IEC 61076-2-101
(Second edition – 2008)

Connectors for electronic equipment – Product requirements –
Part 2-101: Circular connectors – Detail specification for M12 connectors with screw-locking

CORRIGENDUM 1

Figure 27 – Pin front view 5 way with C-coding

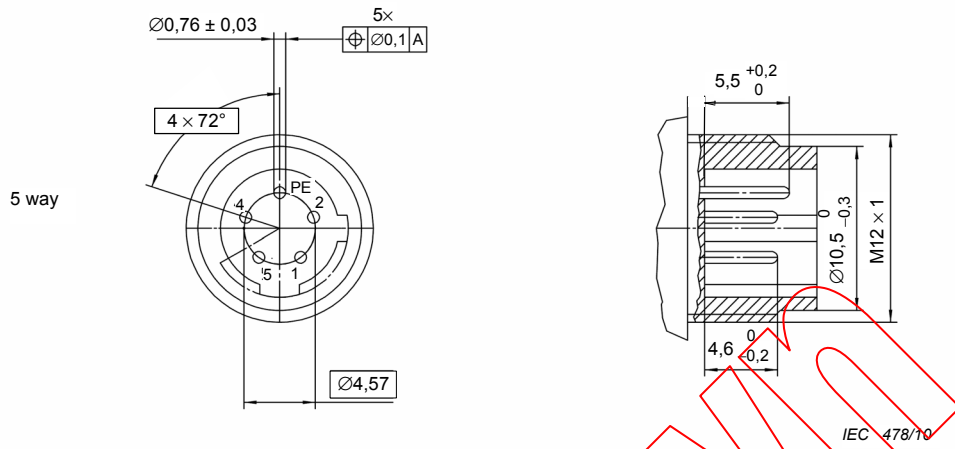
Replace existing **Figure 27 – Pin front view 5 way with C-coding**, by the following:
